**MEMORANDUM**

DATE: August 30, 2001
TO: Montgomery County Planning Board
VIA: Joe R. Davis, Chief *JRD*
 Development Review Division
FROM: Larry Ponsford AIA AICP *LRP*
 Planning Department Staff
 (301) 495-4576

REVIEW TYPE: Site Plan Review
APPLYING FOR: Approval of 33,200 gsf office on 4.49 acres
PROJECT NAME: Gateway 270 Corporate Park, Lot 7
CASE #: 8-01034
REVIEW BASIS: Sec. 59-D-3, M. C. Zoning Ordinance

PROJECT DESCRIPTION: Proposal

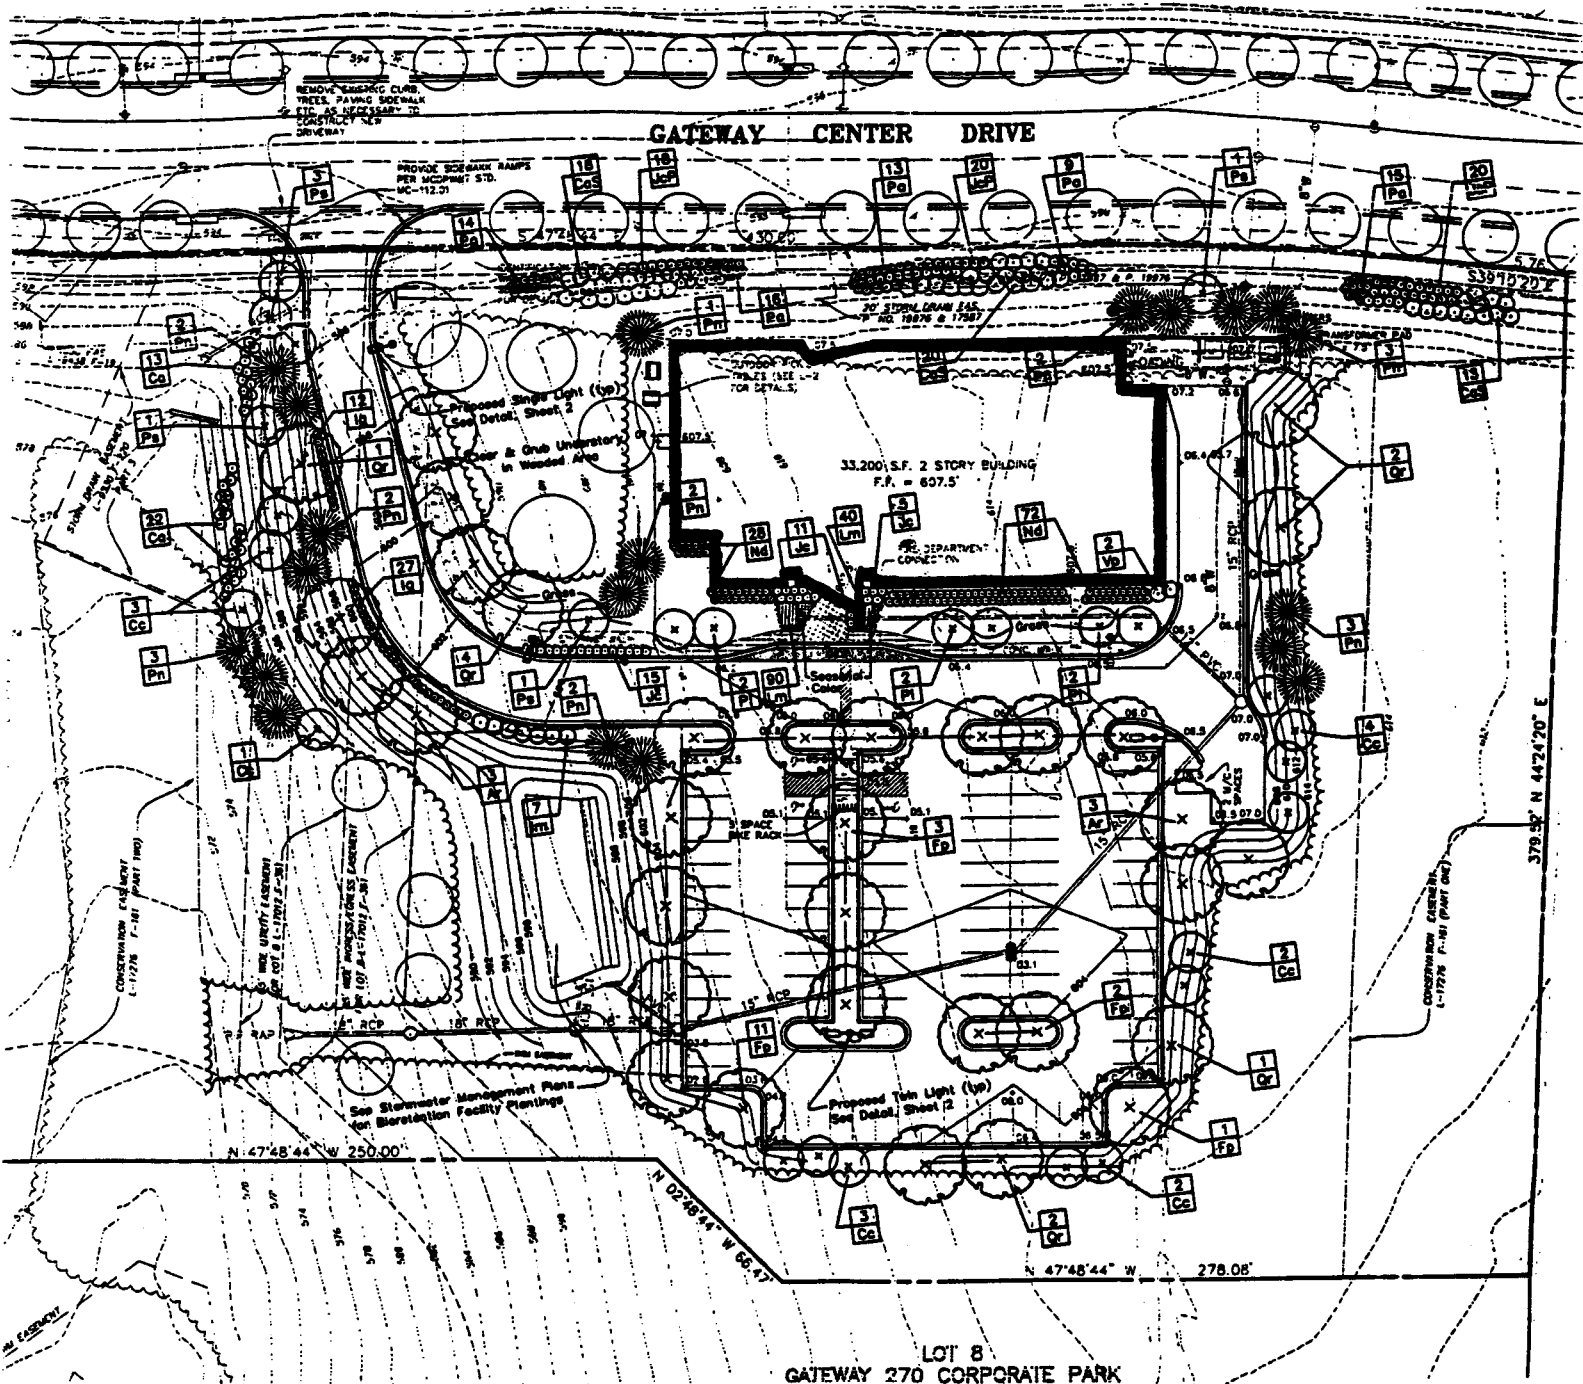
1. Standard Conditions dated October 10, 1995, Appendix A
2. Vacate existing access easement to Lot 8 to preserve existing trees
3. Record new pedestrian and vehicular access easement to Lot 8 along proposed driveway and through proposed parking lot to rear lot line

4. Vacate existing utility easement to Lot 8; relocate and rerecord to preserve existing trees
5. Update information on owner of Lot 8 (Potomac Edison)
6. Enlarge curb radius on northernmost parking lot island to allow for possible future truck turning movements en route to Lot 8

7. Widen "street tree" strip along driveway to six feet by narrowing driveway to 23 feet; move trees to tree strip on both sides of driveway; narrow sidewalk to four feet

8. Planting list and landscape plan for cut and fill slopes subject to adjustment by staff on Signature Set
9. Provide detailed Landscape Plan for entry plaza at scale of 1"=10' or 1/8"=1'-0"
